FACILITY: Catawba Nuclear Station, Units 1 and 2

SUBJECT: SUMMARY OF MARCH 16, 1994, MEETING WITH DUKE POWER COMPANY ON
RCS FLOW MEASUREMENT METHODOLOGY

QUESTIONS ON PROPOSED TS CHANGE FOR CATAWBA/MCGUIRE RCS FLOW-RATE MEASUREMENT

CNS-1 Flow Comparison Between Analytical Flow Prediction, Proposed Elbow Tap Method And Calorimetric Flow

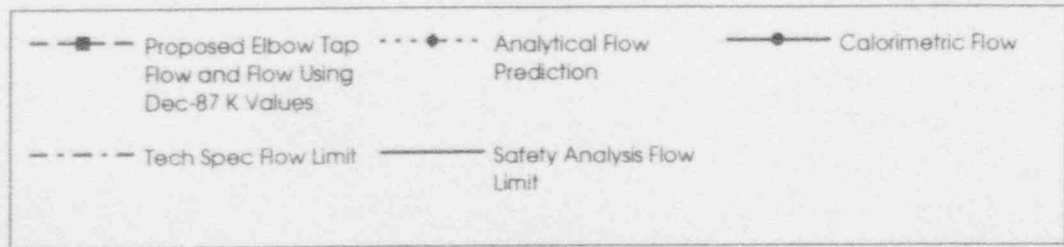
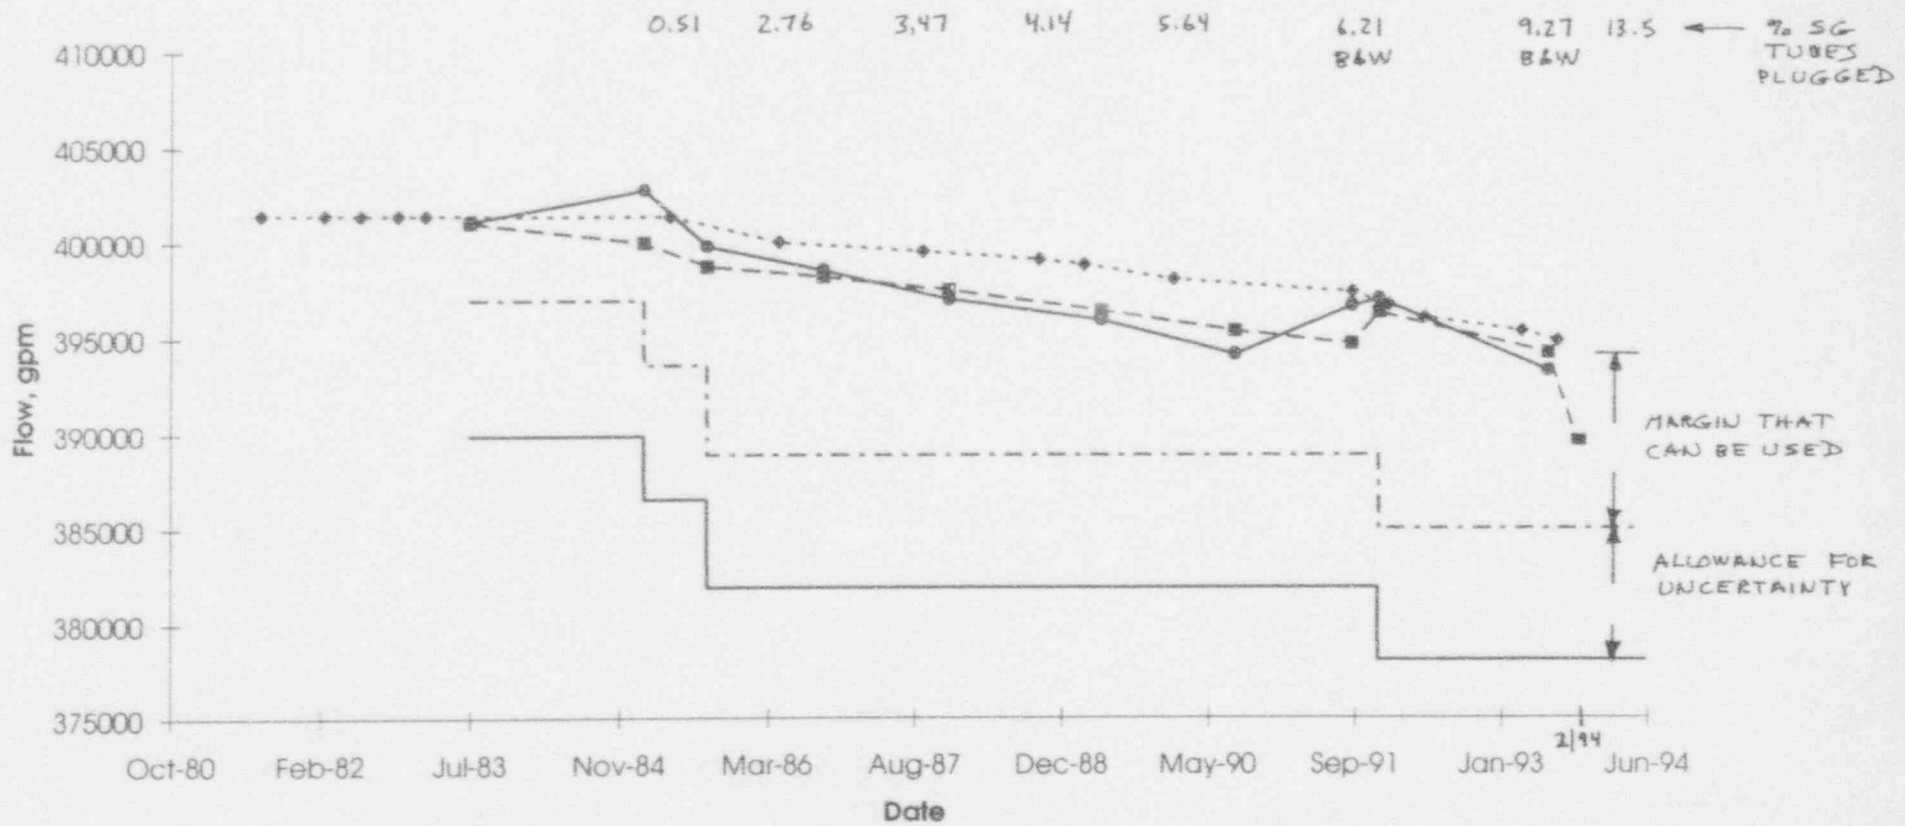
The plot for the calorimetric flow rate has generally close agreement with your proposed elbow tap method, except for the data point taken after December 88. However, the calorimetric flow rate deviates sharply lower from your proposed method for the data taken after September 91.

(a) Please explain the reason for the greater deviation experienced for figure 3 for data taken after September 91. Is this from an increased radial peaking profile in your low leakage core loading? If so, do you have plans for further increases in this profile?

(b) Please provide information on the effect of this large increase in SG tube plugging on the RCS flow rate and also the effect of hot leg streaming for this cycle on RCS flow rate. Is this reduction in RCS flow rate for this current cycle mostly due to SG tube plugging rather than from hot leg streaming? If so, is this not a realistic reduction in flow rate, rather than a false indication from an inaccurate hot leg reading?

The deviation of the calorimetric flow from the proposed elbow tap flow is due to hot leg streaming. The elbow tap flow is determined from the change in the elbow tap ΔP s and is not subject to the effects of hot leg streaming. This flow correlates well with the analytical flow prediction which means the elbow tap indications of flow are trending with plant changes i.e., SG tube plugging. The hot leg streaming change which causes this abrupt downturn in the indicated calorimetric flow is most likely the result of a change in radial peaking profile. As our latest cores are all of the very low leakage design, a slightly increased or shifted peak is the likely cause for the change in hot leg streaming. Future increases in the peaking profile are a possibility as core reload designs are further optimized.

As discussed in the response to question 7a above, the analytical prediction and the elbow tap indication of flow correlate well. The common element between these two plots is that the flow is determined without the influence of hot leg streaming. Also, note that the relative decrease in flow for the last two calorimetrics is proportional to the amount of SG tube plugging. While SG tube plugging is part of the decrease in calorimetric flow, the excessive decrease in flow beyond that shown in the analytical prediction and elbow tap flow is the result of hot leg streaming changes. Below is a table showing the percentage changes in RCS flow for the last three data points from the three methods plotted in Figure 3 of Attachment 3 of the responses to the previous NRC questions.

Percent decrease in calorimetric flow	Percent decrease expected from analytical flow prediction	Percent decrease in elbow tap flow
Jun 91 - Oct 92	1.2%	0.18%	0.12% increase
Oct 92 - Jan 94	2.2%	0.65%	0.65%
